Culver City Unified School District

**ADDENDUM NO. 1
08/30/24**

APPL. No. 03-122987

Culver City High School Press Box Addition
Culver City Unified School District
4401 Elenda Street
Culver City, California 90230

SINGLE LINE DIAGRAM SCALE: NONE 1

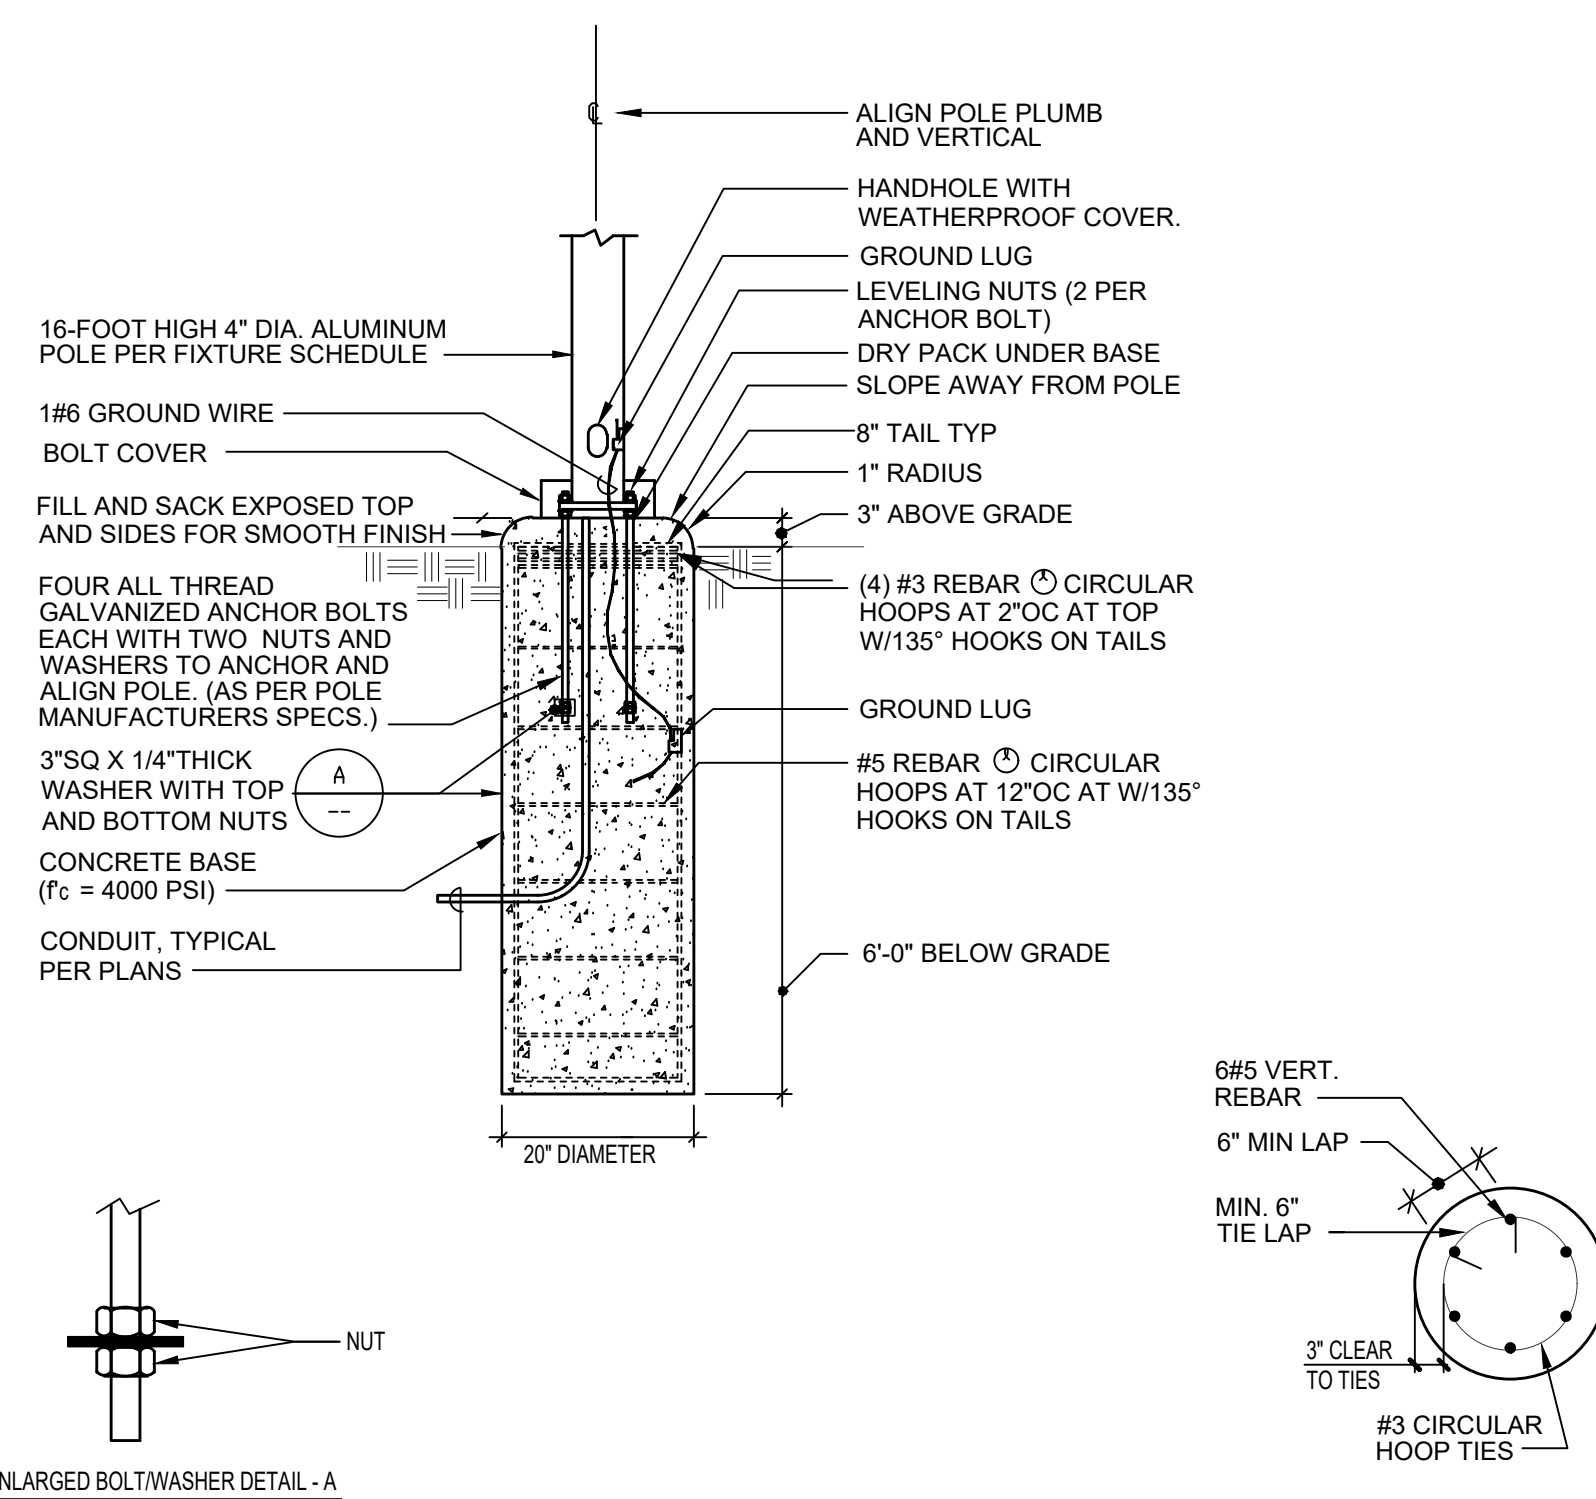
- E-0.2 Reference: Sheet E-0.2, Single Line Diagram, Detail, and Panel Schedules
 - a. Clarified note 2 on detail 1

SITE ELECTRICAL PLAN

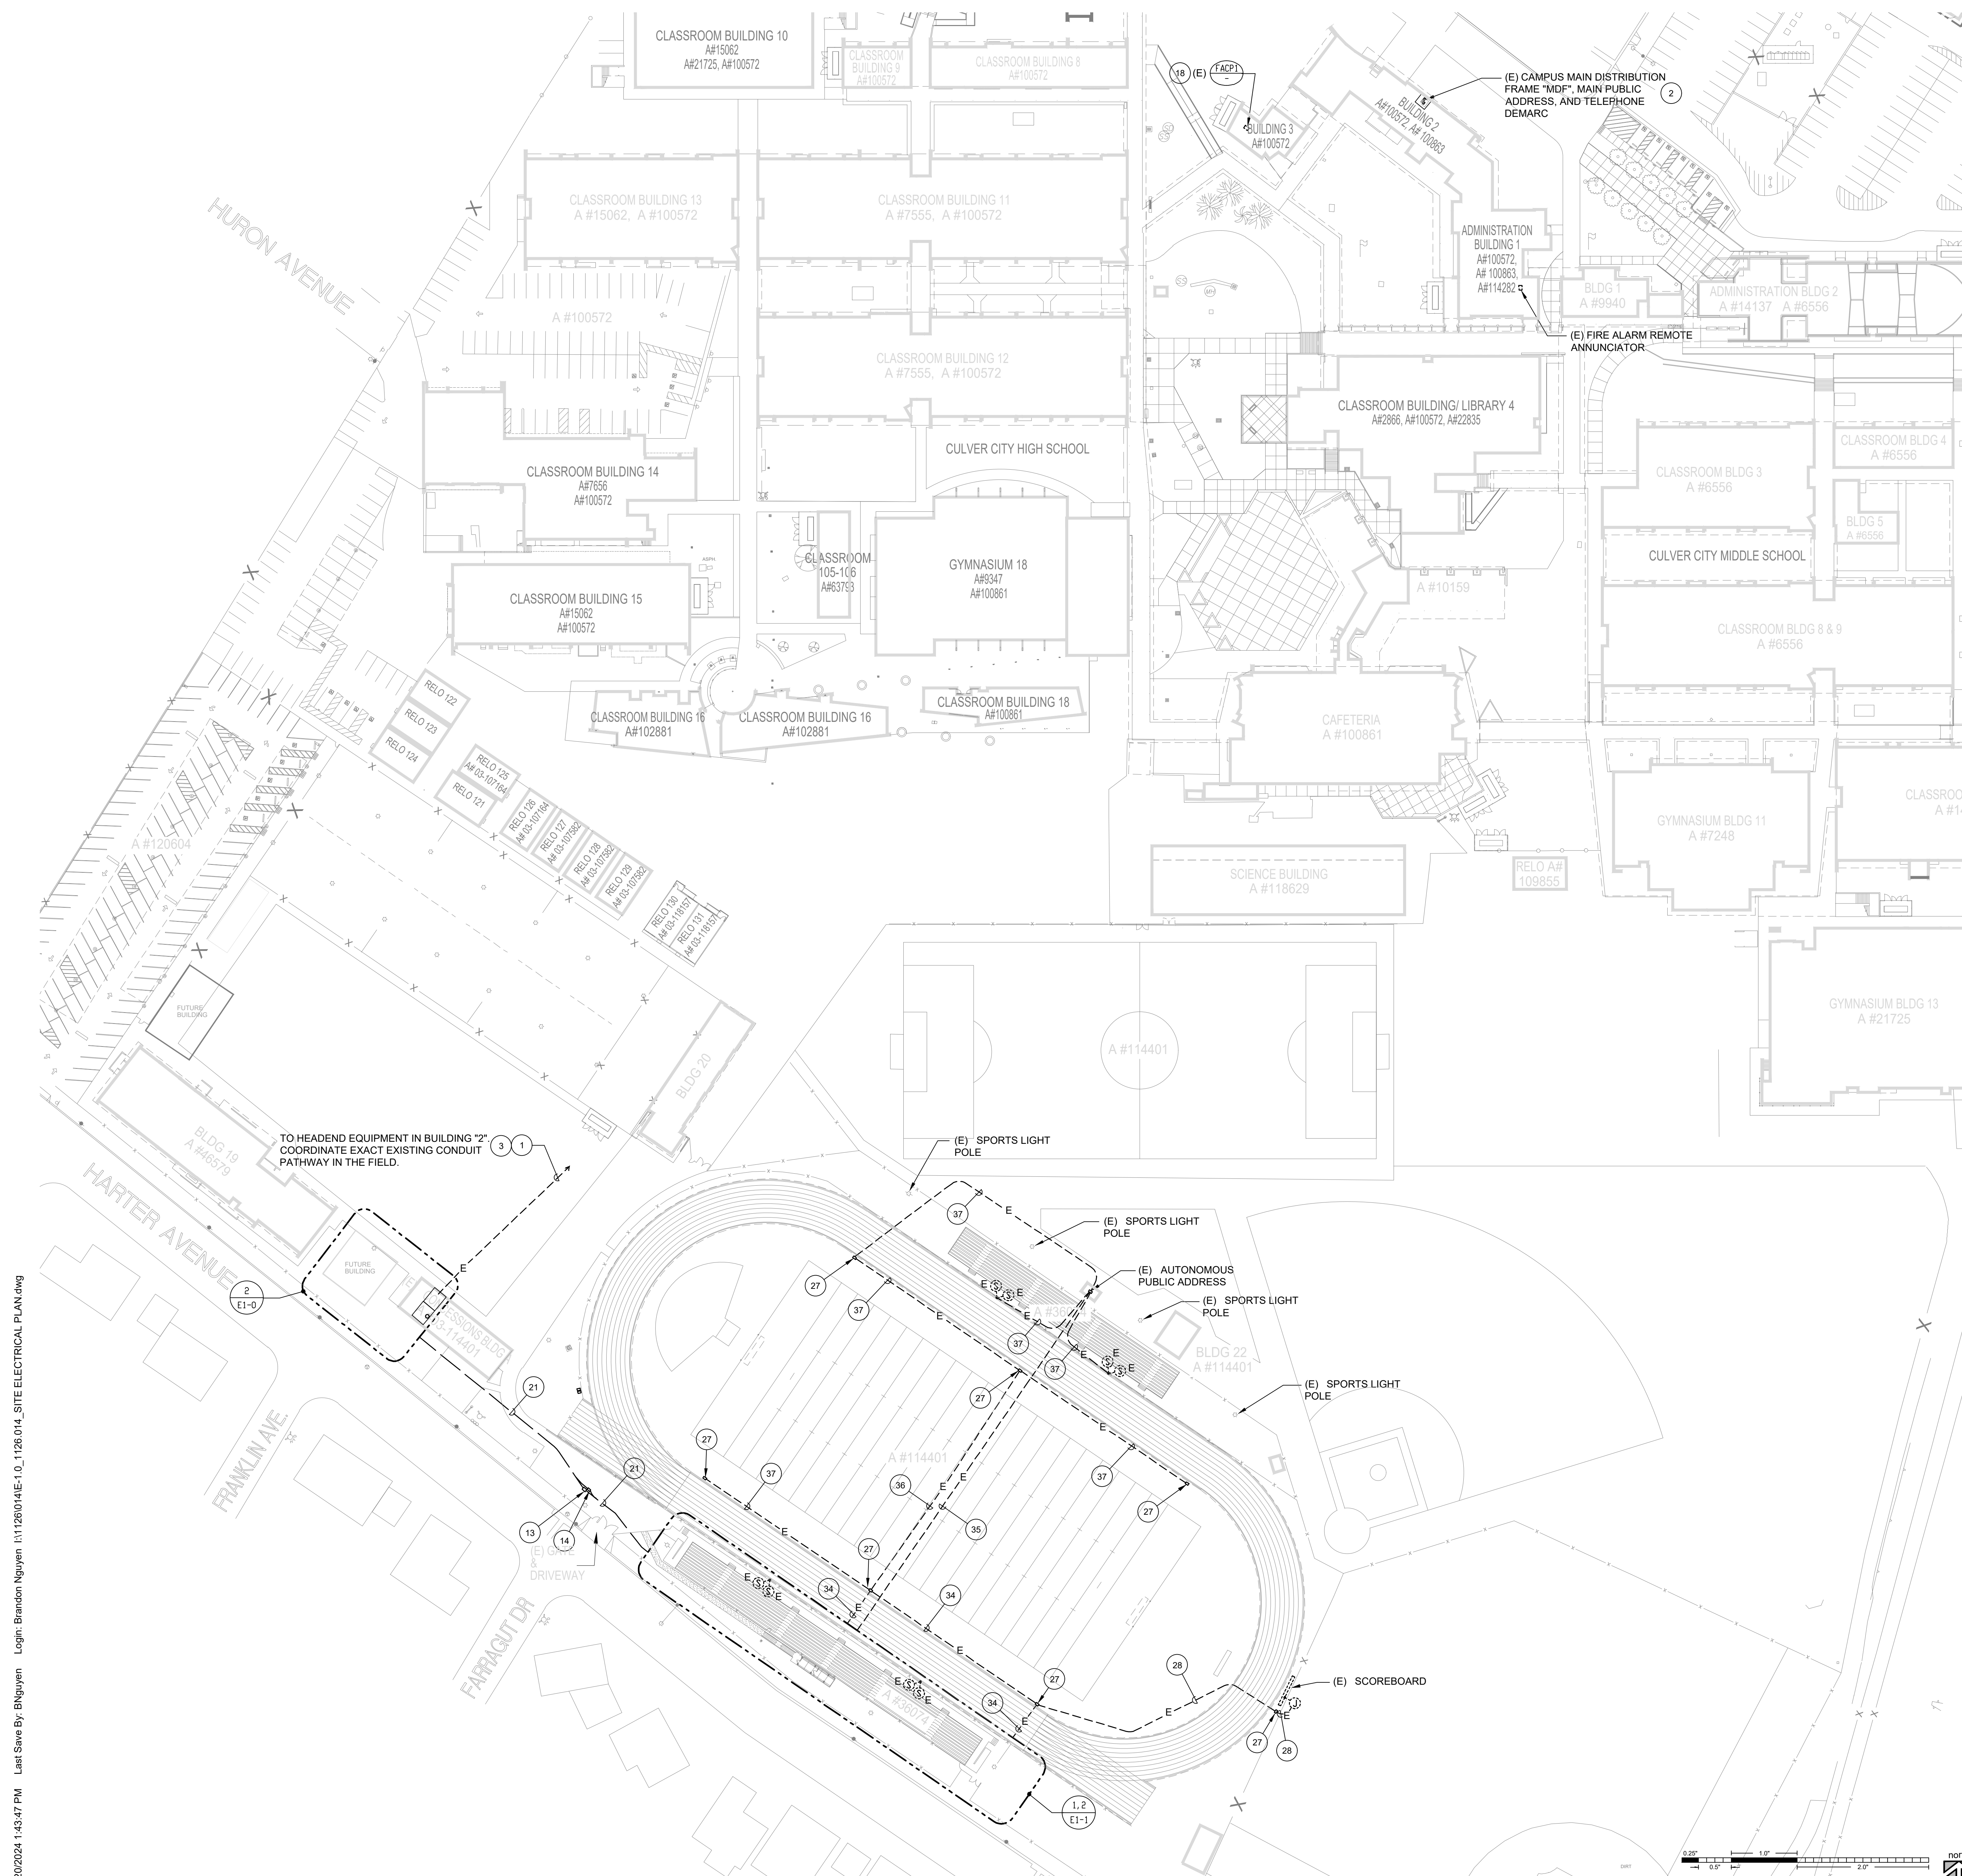
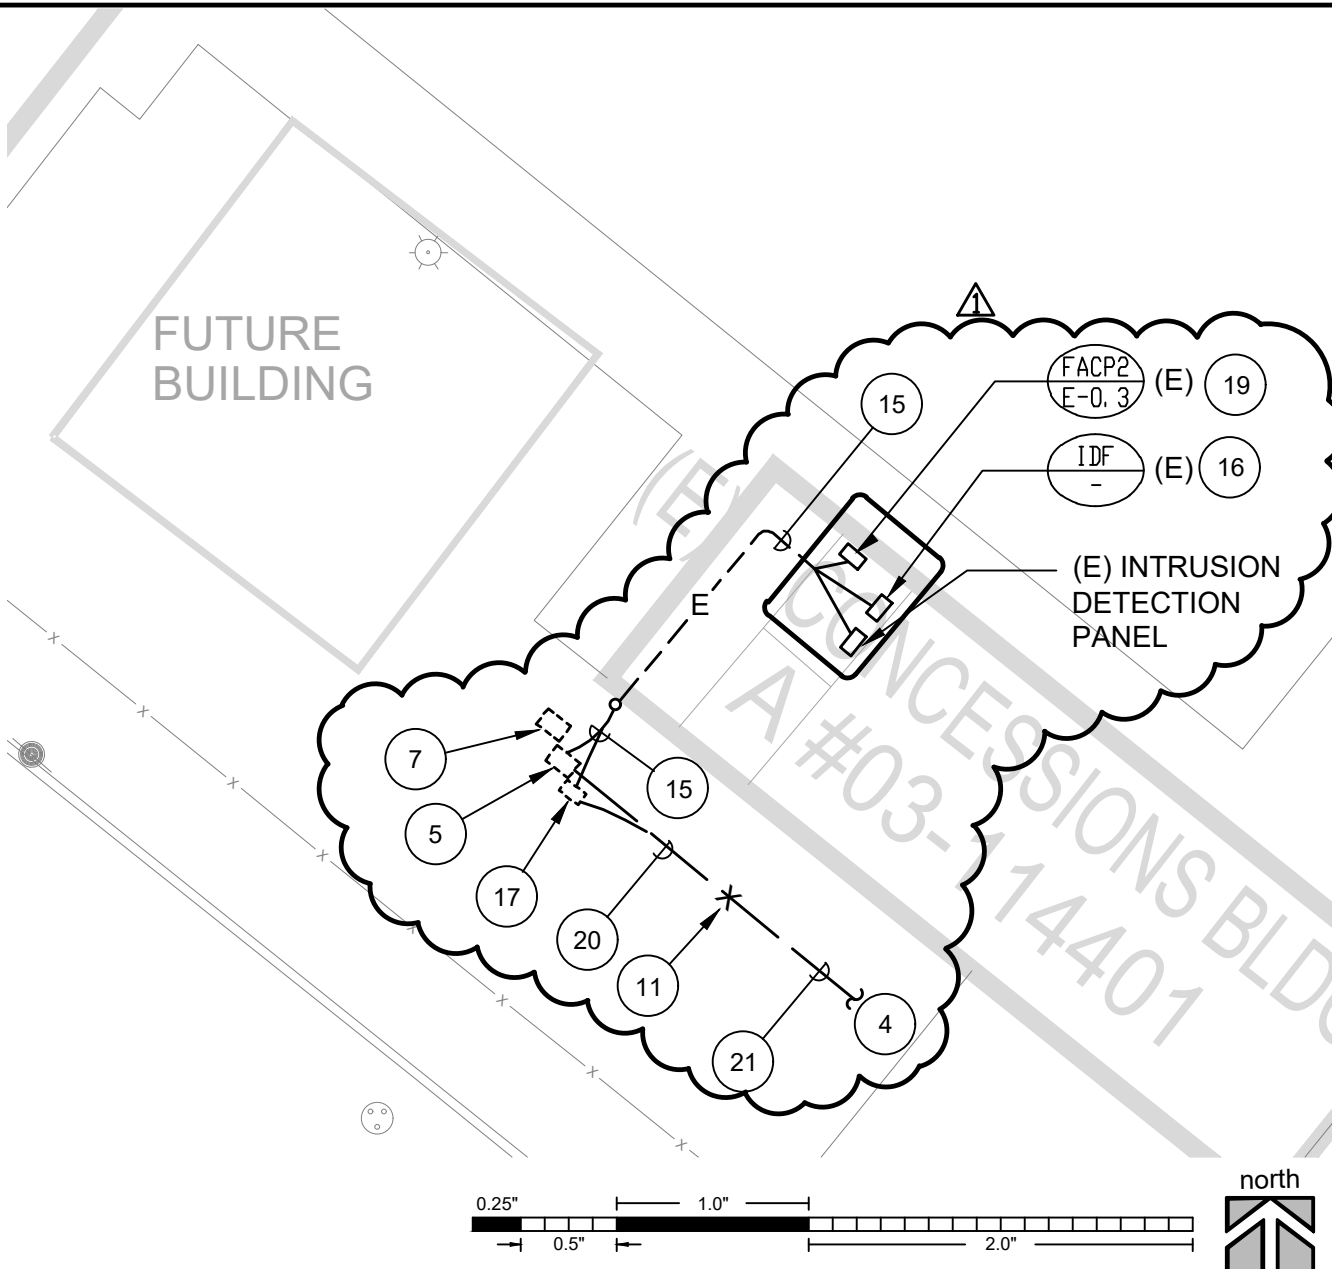
- E-1.0 Reference: Sheet E-1.0, Site Electrical Plan
 - a. Revise enlarged electrical site plan

Sheet Title
ENLARGED SITE ELECTRICAL PLAN

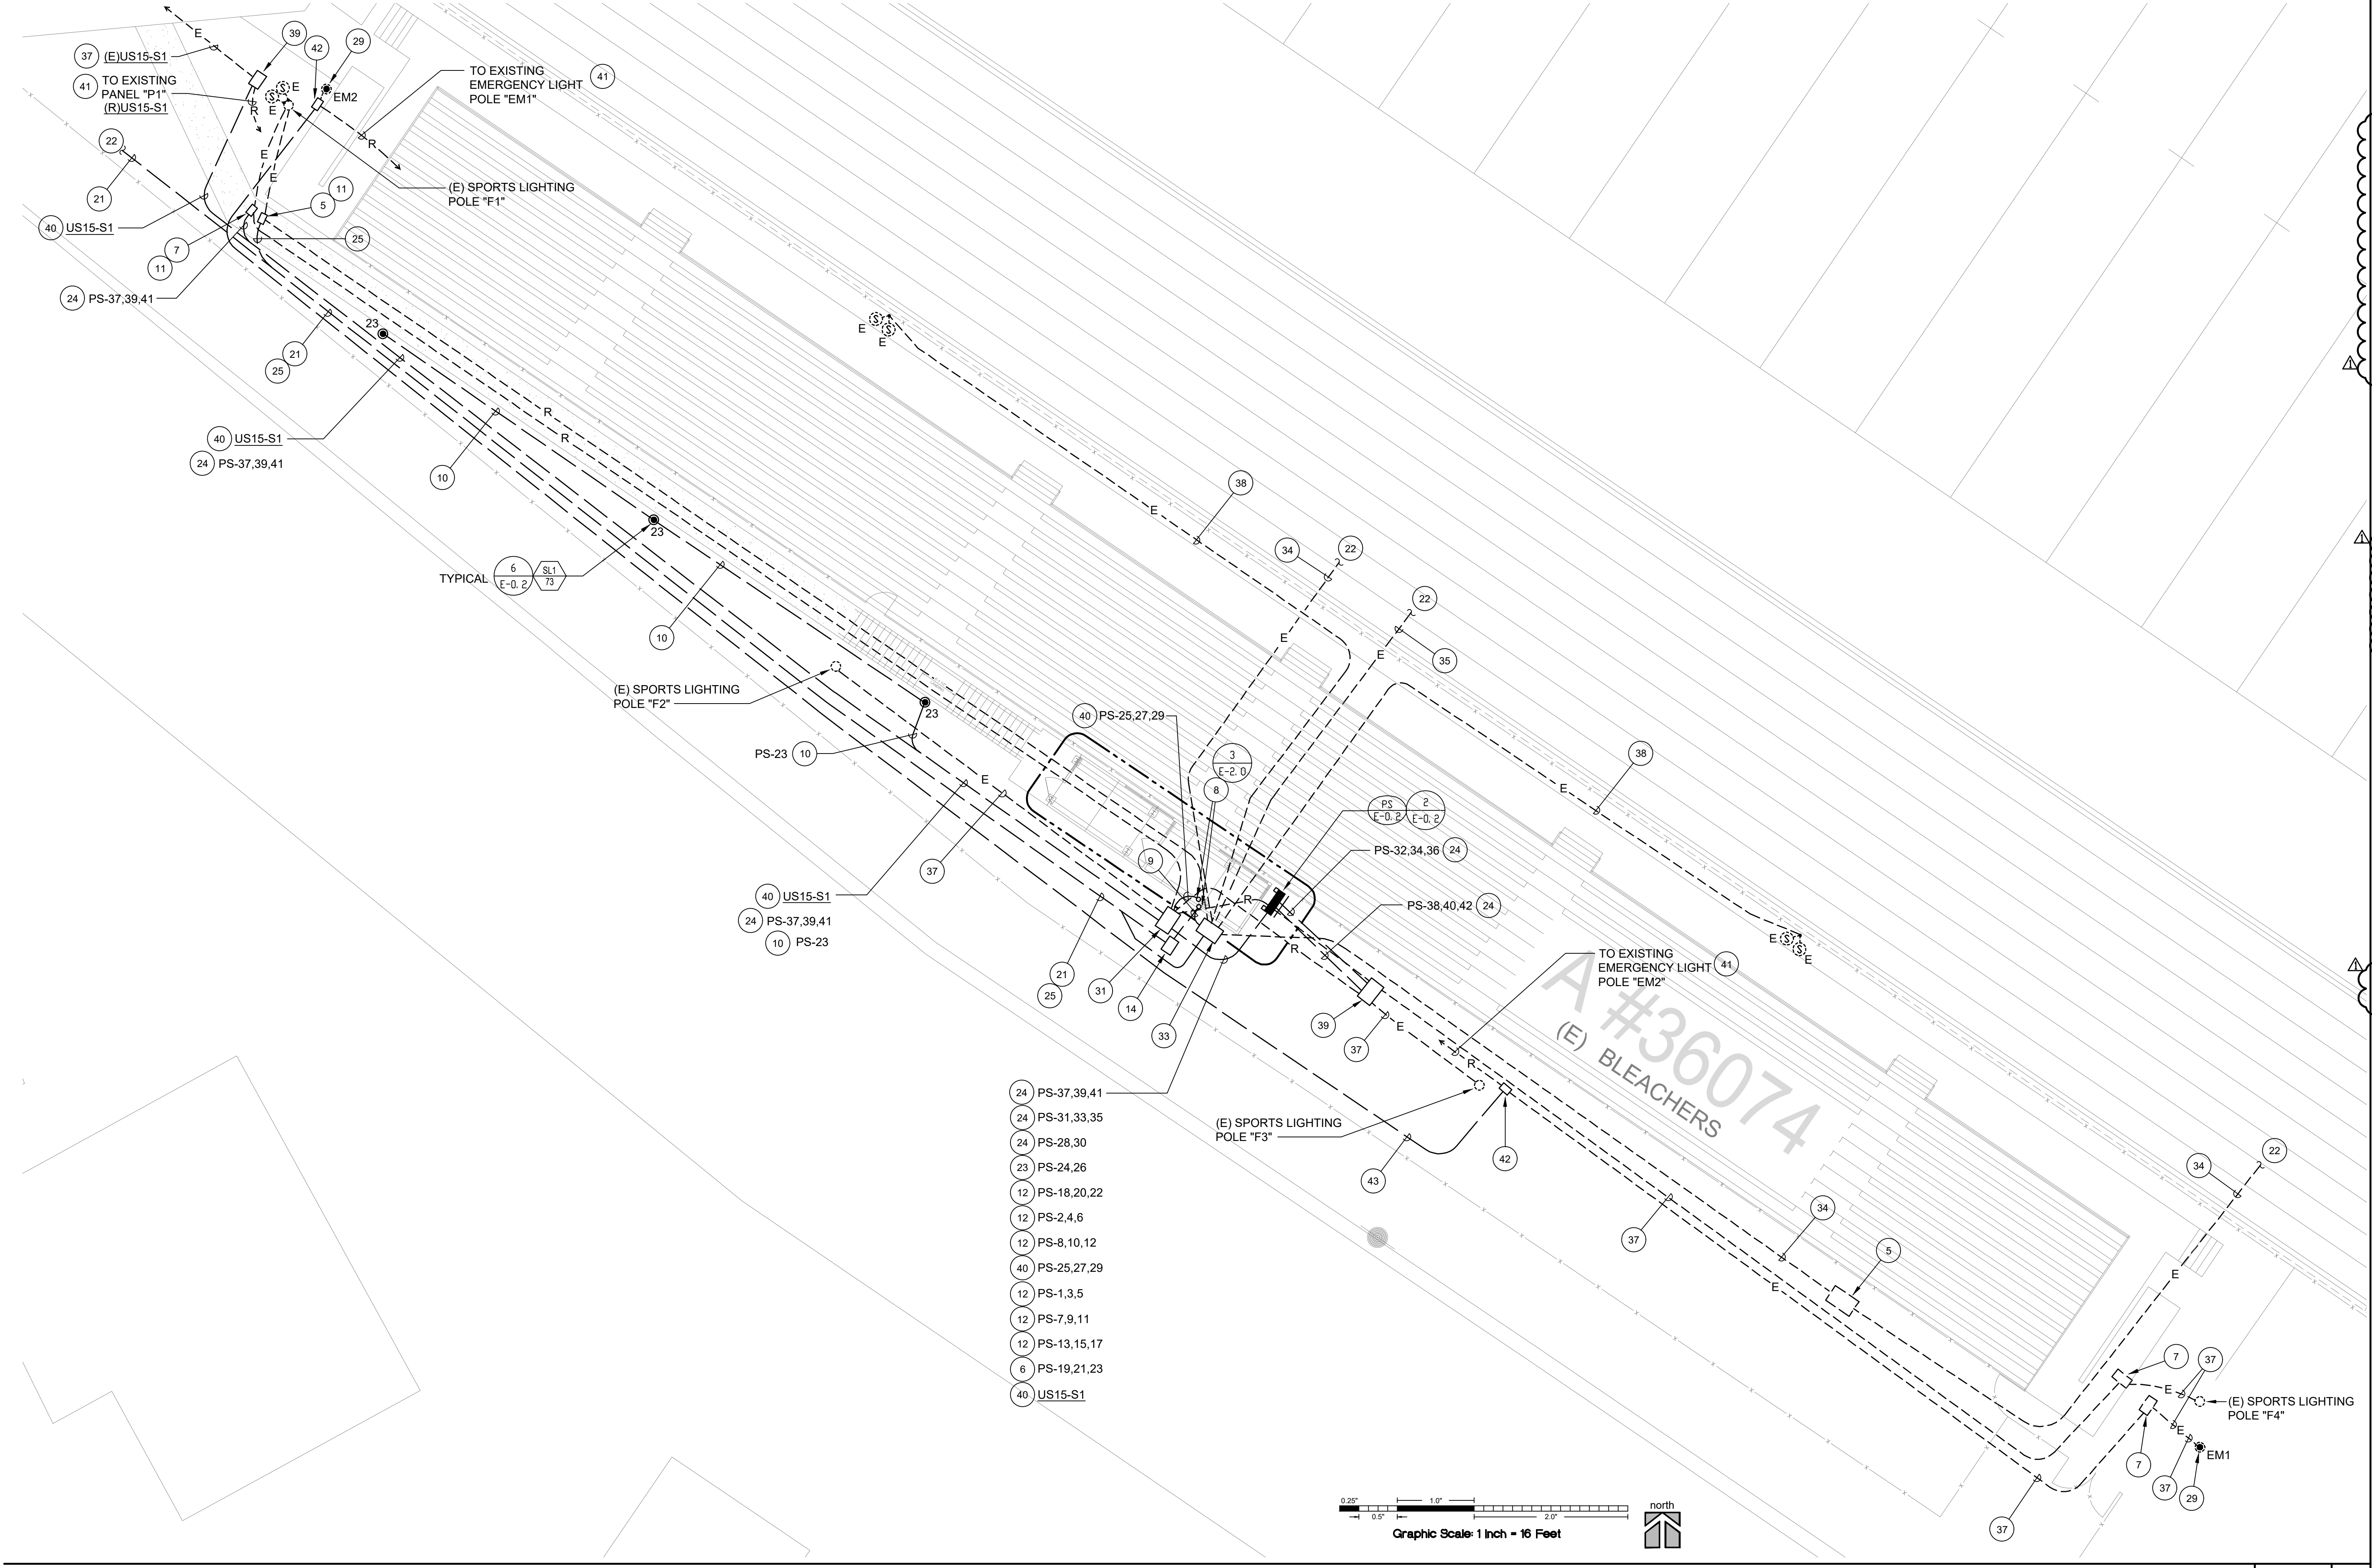
- E-1.1 Reference: Sheet E-1.1, Enlarged Site Electrical Plan
 - a. Revise plan notes
